Amendments to the Drawings:

REMARKS

Appl. No. 10/661,808
Amdt. Dated July 18, 2006
Reply to Office Action of March 29, 2006
Annotated Sheet Showing Changes

FIG. 1 (PRIOR ART)

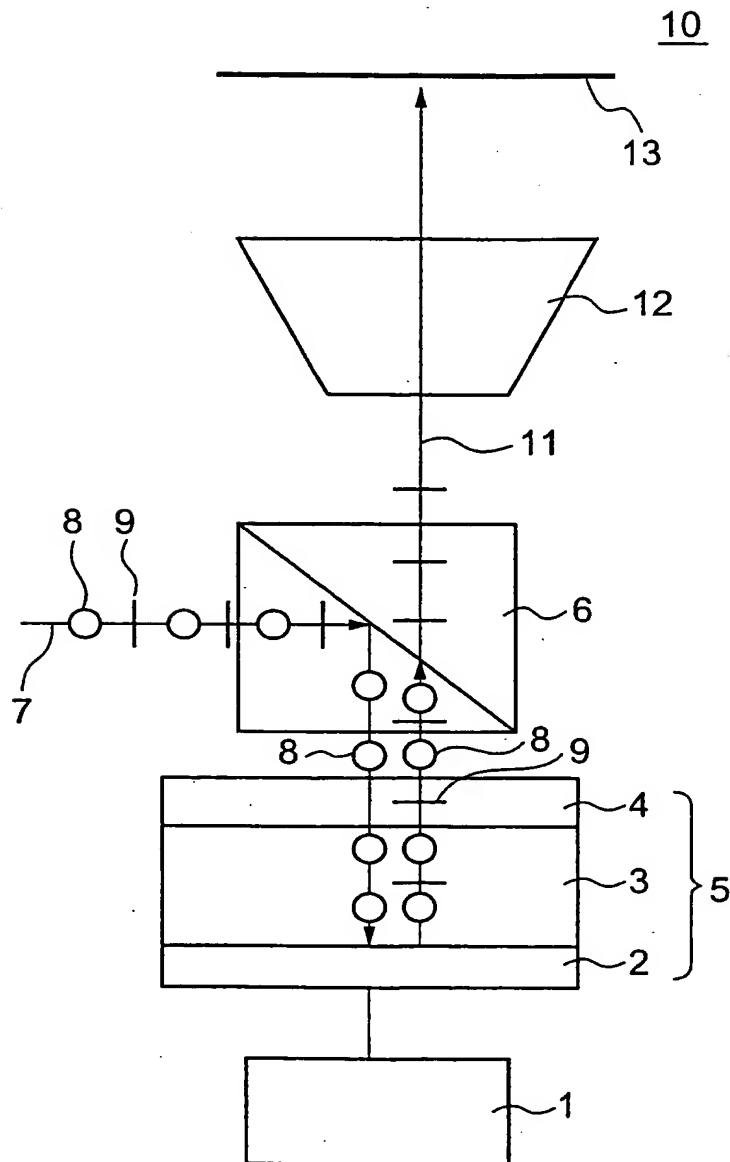
The drawing have been objected as failing to provide the legend of –Prior Art – to indicate the conventional art.

It is respectfully submitted that the Figs. 1 – 9 have been amended to provide the legend of –Prior Art – to indicate the conventional art. It is respectfully submitted that there is sufficient support for the amended Figs. 1 – 9 in the specification, especially the descriptions at page 8, lines 16 – 36 of the specification.
